UNITED STATES PATENT AND TRADEMARK OFFICE

Office Action Summary

10/633,107

This is the first Office Action for application number 10/663,107 License Plate Holding Bracket and the Holding Structure thereof, filed on 9/16/03. Claims 1-21 are pending. This application claims priority to Japan 2002-270020, 2002-270040, 2002-270044, 2002-270109, 2002-270116 all dated 9/17/02.

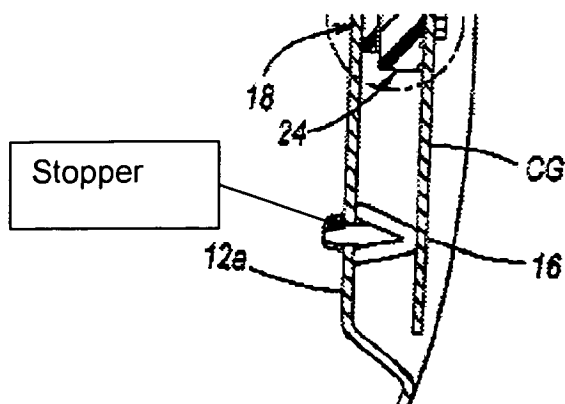
Smith discloses applicant's basic inventive concept including wherein the end side of the fixing member and the plate holding member are connected and both have a plane shape, and a stopper member (See Drawing Below, Fig. 6).

Smith does not teach wherein the stopper member resides on the plate holding member and is brought into contact with the rear bumper of a vehicle when the tailgate is horizontal and the license plate is almost erect with respect to the tailgate and contacts the tailgate and the gate side fixing member when the license plate is parallel to the tailgate and wherein the tailgate has a cavity for receiving the stopper.
